Urban Design Review Panel Comments with Applicant Response

RESPONSE TO UDRP

CHANGE SUMMARY

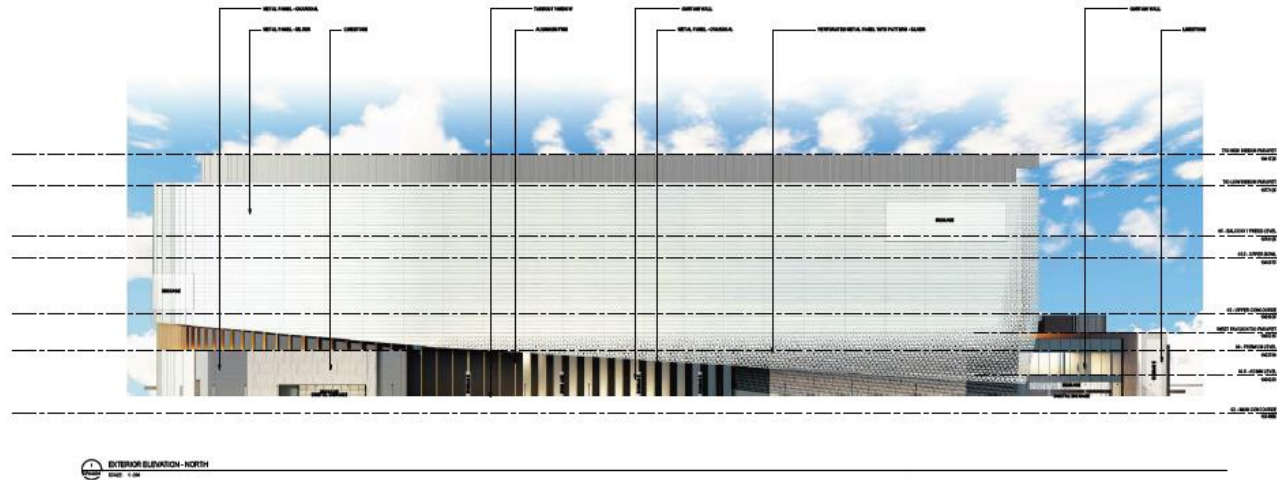
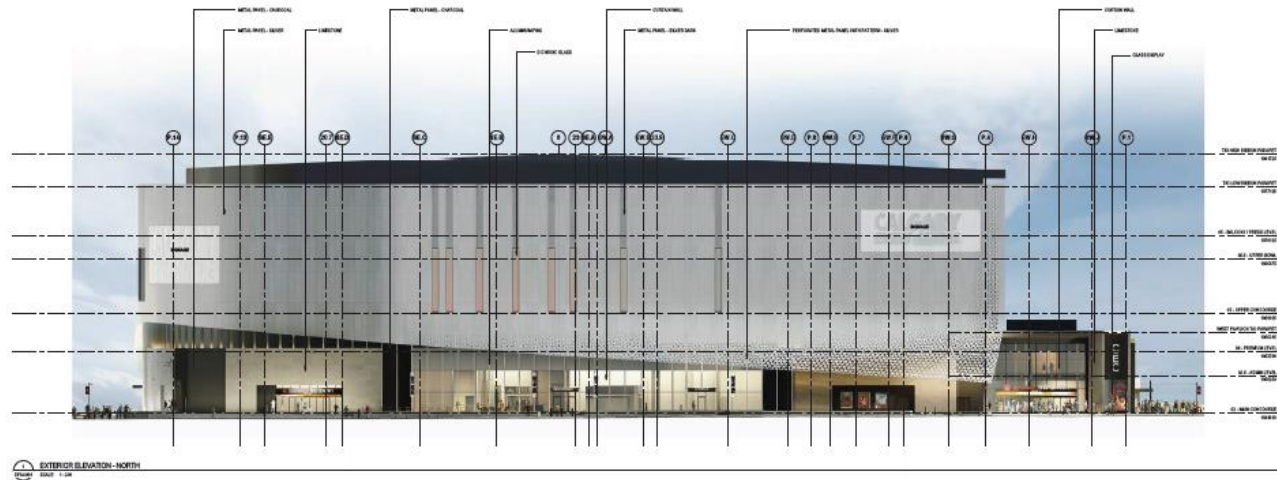
The NW entrance and adjacent exterior space is undersized in relation to the stated importance of this entry being a "formal" front door and face to the City. 12th Avenue SE is also characterized as the site's main connection to the Beltline.

The panel recommends that that the configuration of this important corner be revisited, and street accessible CRUs be added closer to the entry to promote activation beyond Stampede Trail along 12th Avenue. This will assist in the activation of the street by the amenity program currently noted approximately mid-block along 12th Avenue. The fins at this location are very tall and imposing – the street entrances to these retail units will benefit from human scaled design elements.

Additional retail space and glass has been added on 12th Ave closer to the northwest entry. The solid wall that remains has been accented with a slightly recessed change in material that hosts a series of poster boxes. Revisions have been made to the CRU fronts to increase visual connection from exterior to interior.

The stone on the northwest corner has been replaced by a display window and signage. Windows and a material change have been added to upper north elevation (the 'ribbon').

EXTERIOR ELEVATION - SOUTH
SHEET 1.04

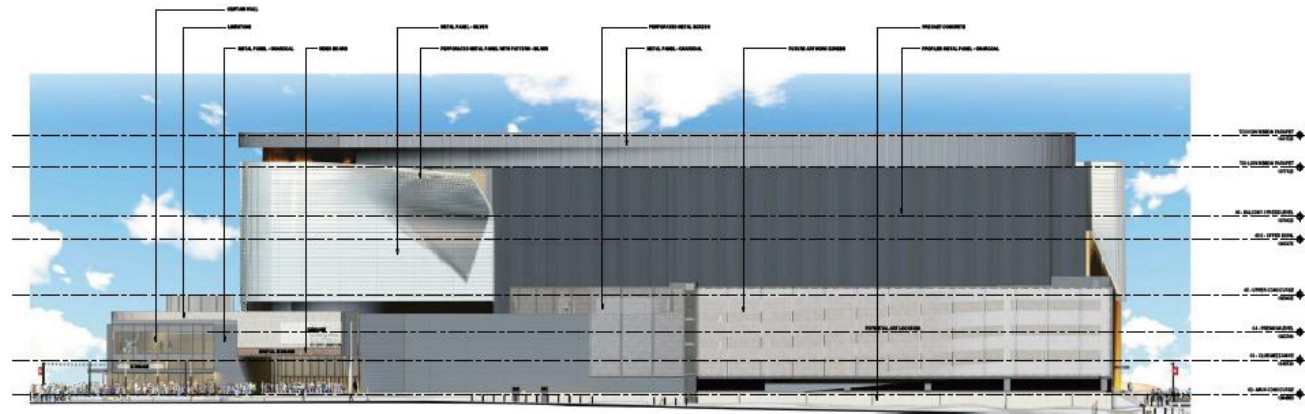
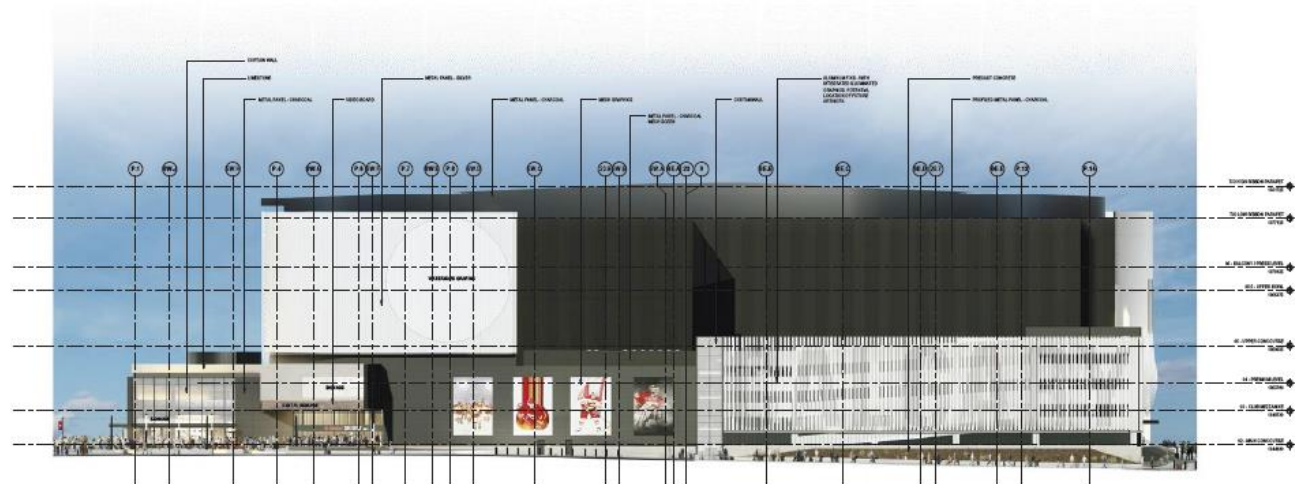
The Applicant notes that 14 Avenue SE "...is becoming an important pedestrian route between Stampede Park and Enmax Park as it offers the most direct link from the Elbow River Bridge". As such, the Panel recommends that further development of the urban realm and building façade be undertaken to address the importance of 14th Avenue with its greater context beyond the operational realities of the site itself. As the South façade of the building will interface with the future Event Plaza identified in the Rivers District Master Plan, the material treatments and overall design should be reflective of this future interface, and not function only as the rear of the building as currently envisioned for most of the façade. This extends to the parkade façade detailing as previously noted in the general commentary.

4 Avenue SE is defined by the Entry Plaza to the west and an open-air parkade to the east. The Entry Plaza is aligned across the avenue with the future Festival Plaza indicated in the Rivers District Master Plan (RDMP) to the south. To better address this plaza the low scale planter along the south edge has been reduced and opened up to provide greater porosity. A four-panel mesh billboard has also been added to create visual interest on the south building elevation visible from the plaza. Further east, the parkade screen has been revised to a series of tightly spaced, tapered aluminum vertical fins similar to the vertical expression around the building. The fins are augmented with a large graphic that can be read obliquely from the west and east perspectives. There is lighting between the fins and from below. Indigenous landscaping softens the hard edge of the building as the grade drops down to the southeast corner of the site. Although tight, the pedestrian sidewalk width is in excess of the recommended minimum width as per pedestrian modelling done by Bunt and Associates. As well CMLC agreed to encourage pedestrian movement along the south side of 14th Street and the cross section has been revised from the RDMP to provide additional width along the south edge.

Perforated metal panels screening the parkade have been replaced by vertical fins that reflect design elements elsewhere on the building. A graphic application and lighting add visual interest, with particular attention to the view from the proposed festival plaza on the south side of 14 Ave.

EXTERIOR ELEVATION - WEST
SCALE: 1:500

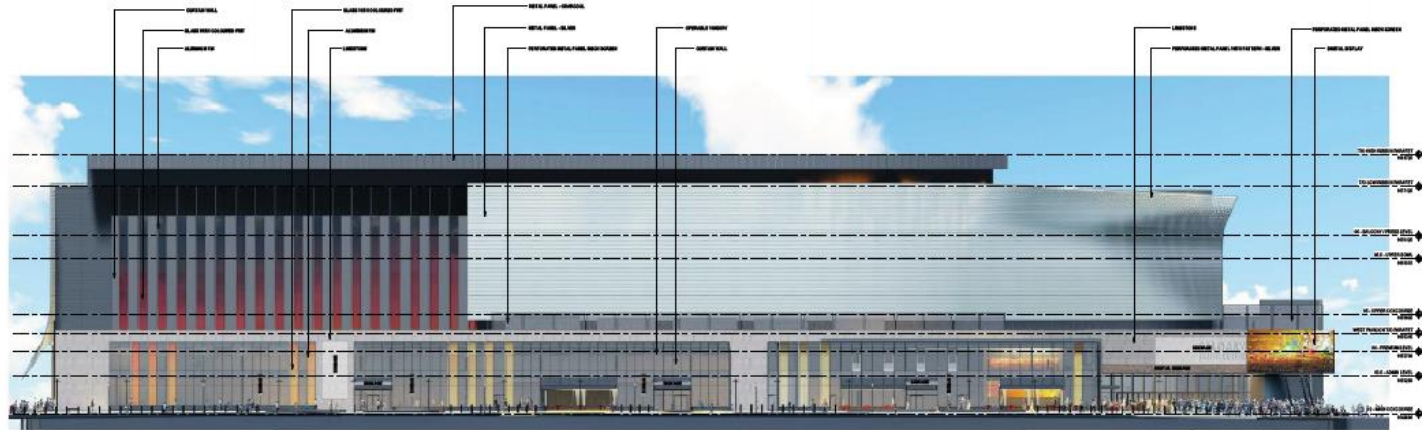
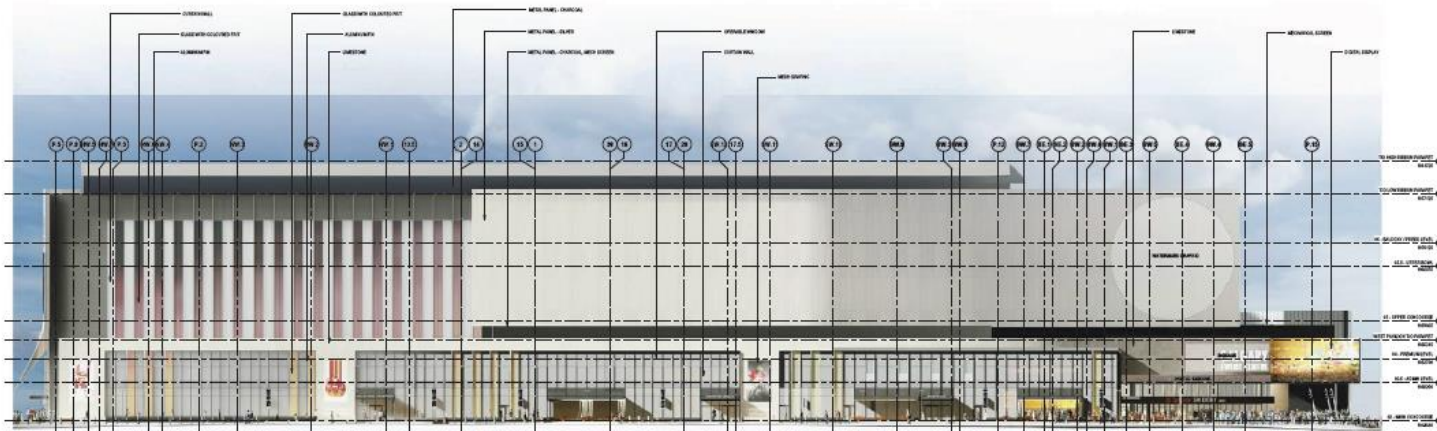
The Ribbon element – a principal building element and material treatment from a contextual viewpoint – requires significant design development. The initial understanding by the Panel was that this element was comprised of a faceted panel design that gradually moved from solid to transparent. This sense is evoked by the schematic renders provided. Through discussion it is understood the majority of the ribbon element will be an insulated panel – noted by the applicant as Kingspan or other similar alternative. The ribbon is large, flat and expressionless and ends abruptly where it is interrupted by the glazing at the west wall as well as at the south elevation.

The Panel recommends that the design be further developed to provide more continuity throughout the entire ribbon element and to expand the essence of movement and lightness that the element is trying to evoke as the "sky" element. The Panel identifies the potential for additional parametric movements similar to the "unraveling" at the ends as presented.

The ribbon to the west addresses the more urban side of the building setting up the entrance to Stampede Park. The ribbon will act as a clean, elegant backdrop to the west pavilion, and integrate the to-be-determined naming rights branding logo. It will also accommodate full screen projection that can be themed to support on-going events in the building, external events such as the ten-day Calgary Stampede festival or dynamic art installations.

Projection and graphics have been added to the upper southwest corner of the building. The extents of the south planter have been reduced to open the plaza more to the future festival plaza planned in the Rivers District Master Plan.
